Re: Caterpillar Clubhouse
803 2nd St. SW
Traffic Circulation Layout
Architect's Stamp 04-01-22 (K14-D227)

DRAINAGE AND TRANSPORTATION INFORMATION SHEET (REV 3/2018)

TRAFFIC CIRCULATION LAYOUT

TCL-1

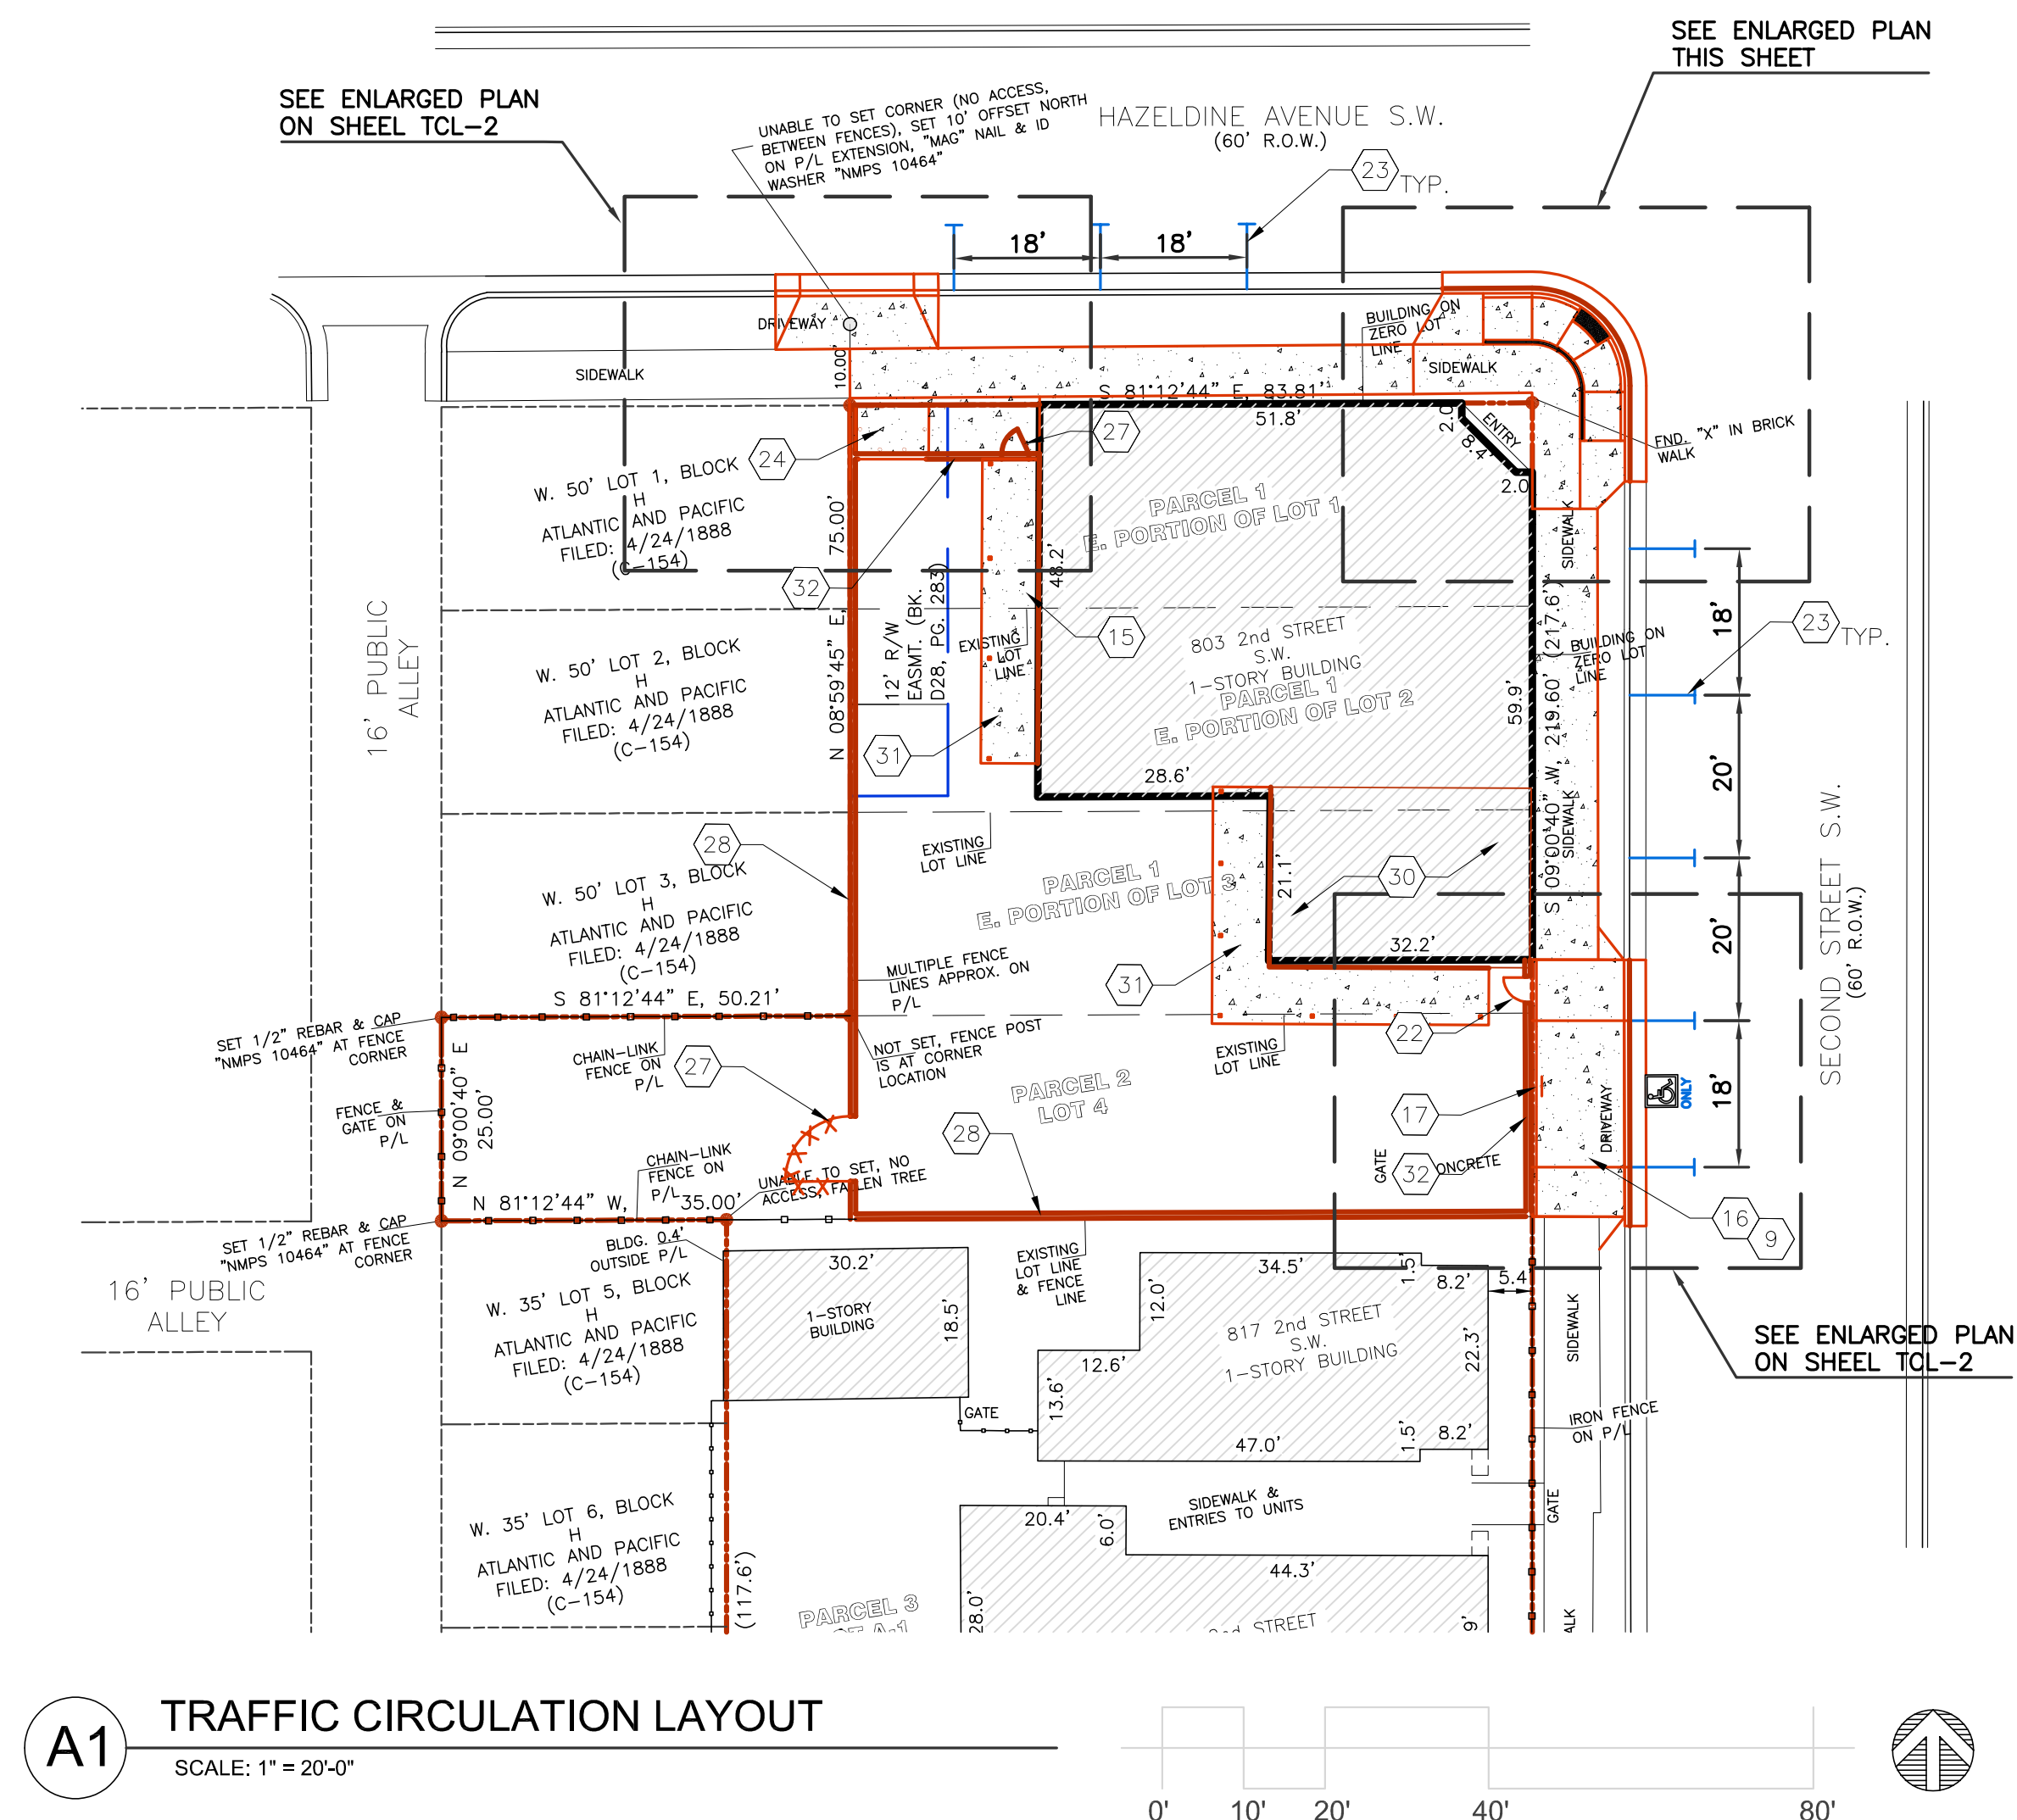
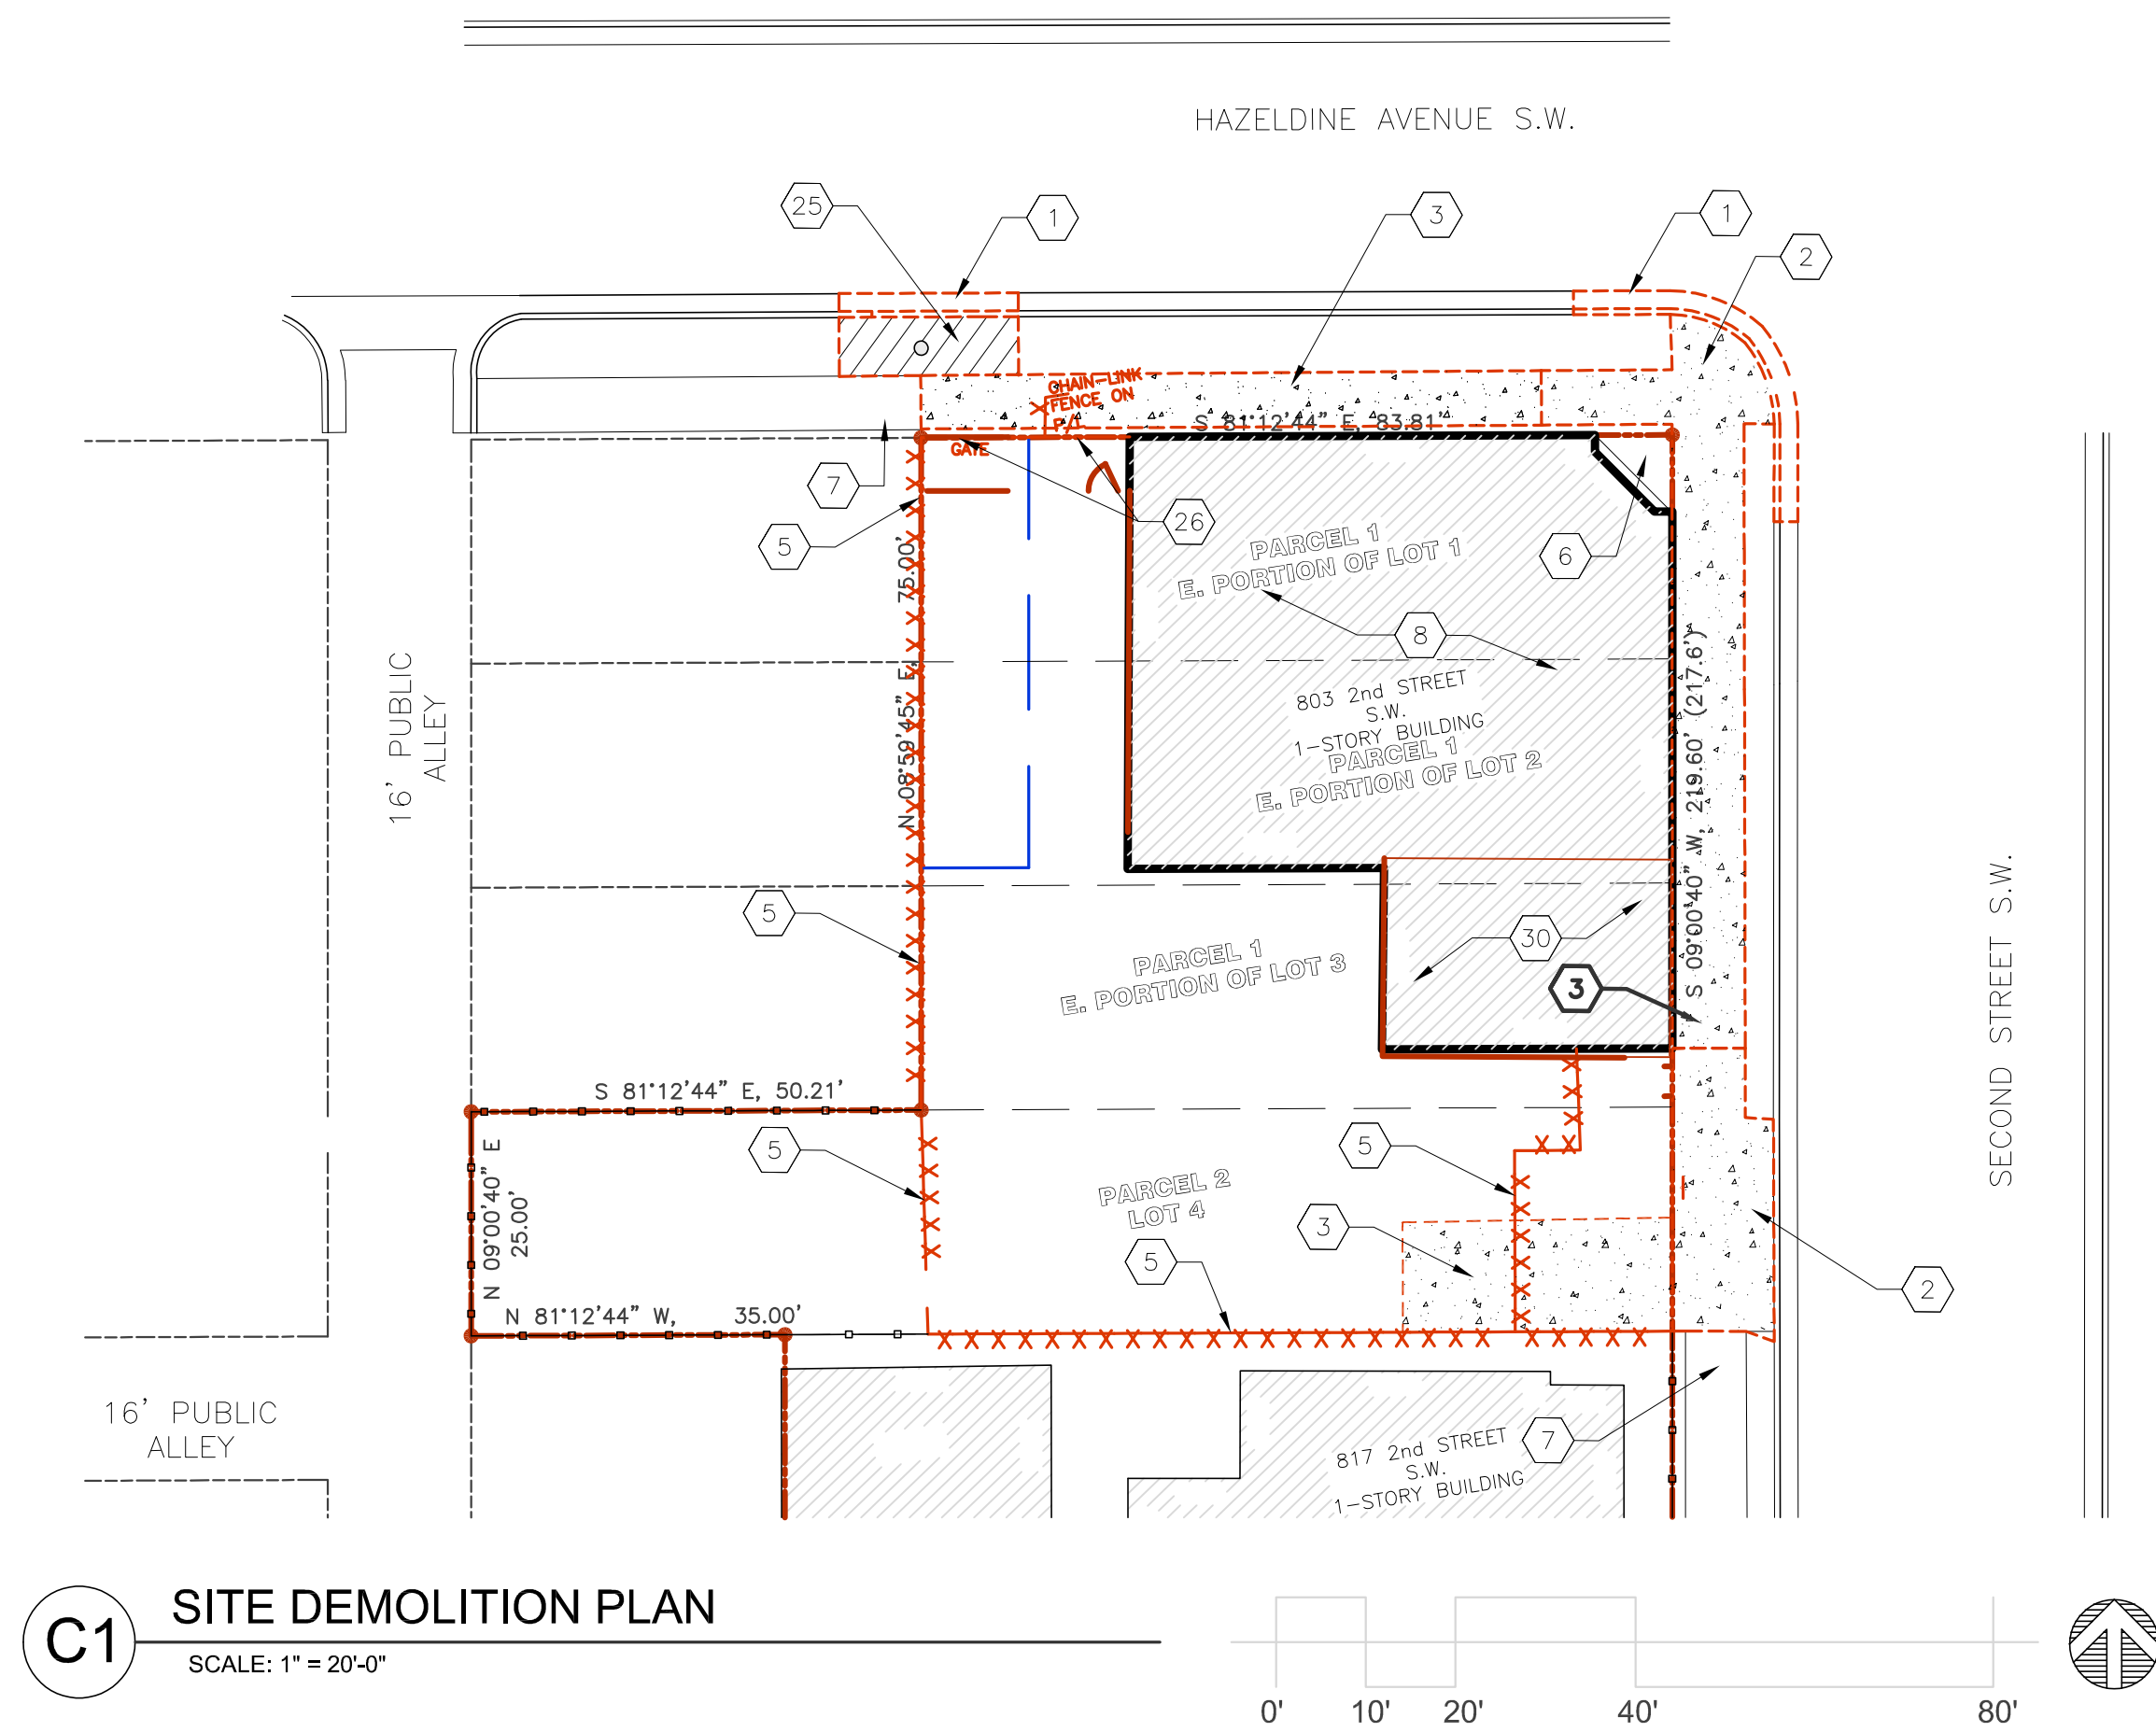
1. List the number of parking spaces required by the IDO as well as the proposed number of parking spaces including bicycle and motorcycle parking.
2. Provide Approved Plat showing the blanket access easement across all these lots for access.

3. ADA parking stall is not permitted on Public Right of Way Per City Engineer.
4. Handrail is not permitted on Public Right of Way Per City Engineer.
5. Call out COA std dwg for the Driveway off 2nd st.

6. Provide the dimension from the on street parking stall to the intersection of 2nd st. and Hazeldine Ave. show this dimension on site plan.
7. On-street parking spaces need to be 20' long.

8. Show the intersection sight distance for the driveway entrance off 2nd St. and add the following note to the plan: "Landscaping and signage will not interfere with clear sight requirements. Therefore, signs, walls, trees, and shrubbery between 3 and 8 feet tall (as measured from the gutter pan) will not be acceptable in the clear sight triangle

9. Show the clear sight triangle for the driveway entrance off Hazeldine Ave. and add the following note to the plan: "Landscaping and signage will not interfere with clear sight requirements. Therefore, signs, walls, trees, and shrubbery between 3 and 8 feet tall (as measured from the gutter pan) will not be acceptable in the clear sight triangle

1. A Zone Atlas Page will be added to the plan to provide the vicinity map.
2. We will coordinate with Zoning on the parking counts. Please note that we do not have any off-street parking provided and Sections 5-5(D)(1) and 5-5(E)(1) call for bicycle parking based on Off-Street parking provided.

3.
 - a. On the prior submittal, the driveway was designed to replace an existing driveway that was degraded. At this time, the access easement that was held by the adjacent property to allow access through the project site, has been vacated. The neighbor has a gate and access to a parking space on the west side of the existing driveway. We can either leave the old driveway there or replace it with our project. We could also widen the driveway to allow for a COA compliant width driveway along the project parcel street frontage.

- b. Plans currently call for KN #9 that requires the concrete drive pad to be built per COA Std Dwgs 2425a and 2425B. Please refer to the enlargement on sheet TCL-2.

- c. Handrails have been proposed because to meet ADA the curb access ramp needs to have sloping sections going west and south from the landing. Also the access door to the building is located very close to this corner and to prevent the public from accidentally stepping off the curb, we feel it would be best to include a simple railing.

- d. On-street parking does meet the DPM that requires that end stalls be 18' long and intermediate stalls be 20' long, both 8' wide for parallel parking. Please see the dimensions on A1/TCL.

- e. The sidewalks around the site are in poor shape. The plans call for public sidewalks along the project frontage to be removed and replaced per COA Std Dwg 2430. Please see plans and KN's #3 and #14. There was a KN #7 that was incorrect on the plan on the 2nd Street side. This has been corrected.

- f. ADA Parking Stalls
 - i. The plans call for a drivepad to ensure that what seems to be sidewalk is built thick enough to allow for vehicular traffic without cracking over time. We are not proposing any on-site parking, just parallel. The sidewalk will be over 8' wide to allow for Van accessible ADA parking/unloading in this area.

- ii. The drivepad is to be thick like 2425 A & B, but to have the sloping sidewalk connections like 2443. This particular location will be a combination of both.

- iii. The header curb is to allow for the 6" grade difference between the bottom landing and the sidewalk that must meet up with grades at the entrance door into the facility. The access door to the building is located very close to this corner and to prevent public from accidentally stepping off the curb, we feel it would be best to include a simple railing.

- iv. A short taper on the sidewalk will be added to help guide the visually impaired in the section of ADA unloading zone on 2nd Street.
- 4. The unloading zone for the Van Accessible parking stall is the adjacent sidewalk. The sidewalk is shown over 8' wide to comply with Van accessibility requirements.

- 5. The Van Accessible parallel parking includes an unloading zone on the sidewalk. There is no striped area that would receive the "NO PARKING" letters.

- 6. Please note that we do not have any off-street parking provided and Section 5-5(D)(1) calls for motorcycle parking based on Off-Street parking provided. We have no off-street parking provided.

- 13. Clear Sight applies when we have driveways into the project site.
- 14. Parking is held back over 30' at the Hazeldine/2nd intersection.
- 15. On the prior submittal, the driveway was designed to replace an existing driveway that was degraded. At this time, the access easement that was held by the adjacent property to allow access through the project site, has been vacated. The neighbor has a gate and access to a parking space on the west side of the existing driveway. We can either leave the old driveway there or replace it with our project. We could also widen the driveway to allow for a COA compliant width driveway along the project parcel street frontage.
